# UNITED STATES PATENT AND TRADEMARK OFFICE

APPLICATION NO.	FILING DATE	FIRST NAMED INVENTOR	ATTORNEY DOCKET NO.	CONFIRMATION NO.
09/990,739	11/16/2001	David H. Harris	5087-27	3310

<b>Office Action Summary</b>	<b>Application No.</b>	<b>Applicant(s)</b>	
	09/990,739	HARRIS ET AL.	
	<b>Examiner</b>	<b>Art Unit</b>	
	Khanh Dang	2111

## DETAILED ACTION

**Fig. 1 of Kobayashi:**

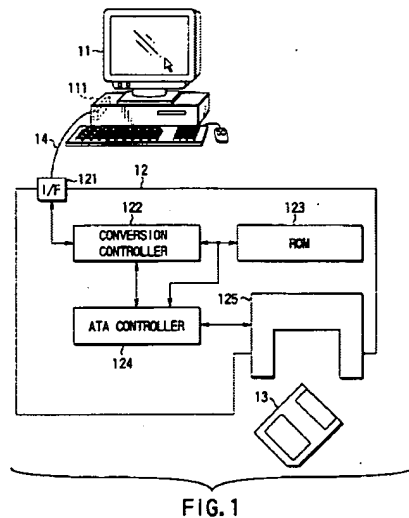
In other words, the difference between the claimed subject matter and that of Kobayashi resides on the fact that the in Kobayashi, the single chip conversion controller 122 resides on the motherboard of the storage device 12, whereas in the instant application, the conversion controller or "bridge circuit" (as claimed in claim 5) is provided on a separate or "secondary" board.

Note that the single chip conversion controller 122 or the so-called "bridge circuit" is provided on the motherboard of the storage device 12.

**Fig. 2 of the instant Application:**

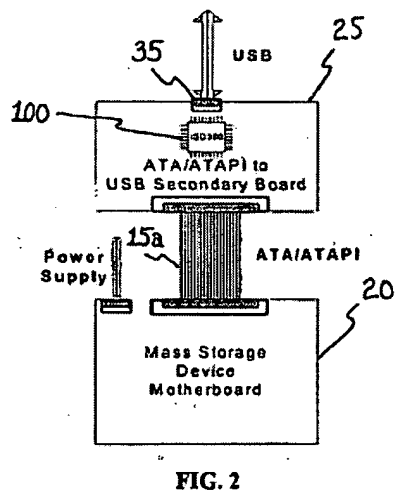
Note that the so-called "bridge circuit" (single chip) 100 is provided on a separate "secondary" board 25, instead of on the motherboard 20 of the storage device.

FIG. 3

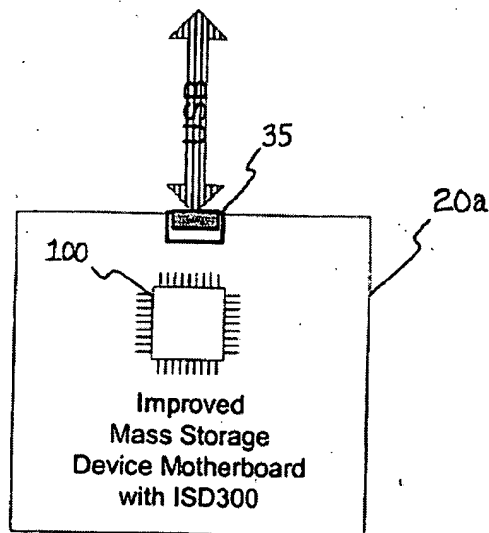
However, it is clear that whether the single chip conversion controller 122 or the so-called "bridge circuit" is provided on the motherboard of the storage device as in Kobayashi, or provided on a separate or "secondary" board as in claim 5, the conversion controller 122 would perform the same function, which is a function of converting between the ATA/ATAPI protocol to the USB protocol and vice versa. As matter of fact, as disclosed in Applicants' summary of the Invention, the crux of Applicants' claimed invention is a single bridging chip for converting ATA/ATAPI protocol to USB protocol and vice versa. The bridging circuit/chip 100 would perform the same function whether the bridging chip 100 is provided on a motherboard of the storage device (page 2, lines 8-12 of the originally filed specification, and Fig. 3):

FIG. 2

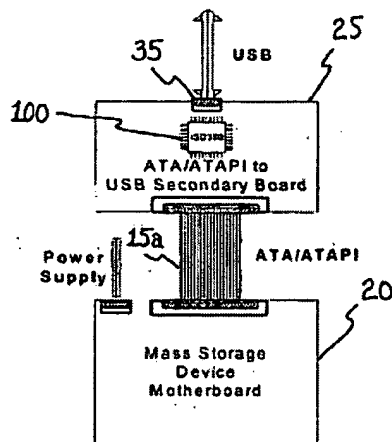
or, **alternatively**, as a design choice, the bridging chip 100 is provided on a secondary board (see page 2, lines 17-21 of the originally filed specification, and Fig. 2)

Thus, it would have been obvious to one of ordinary skill in the art at the time the invention was made to use a separate or "secondary" board for the single chip conversion controller 122 of Kobayashi, since the conversion controller chip 122 of Kobayashi would perform the same function whether on the same board with the storage device 12 or on a separate or "secondary board" and, thus, providing a separate or "secondary board" for the single chip conversion controller 122 of Kobayashi is a matter of design choice, as also acknowledged by Applicants, and only involves ordinary skill in the art.
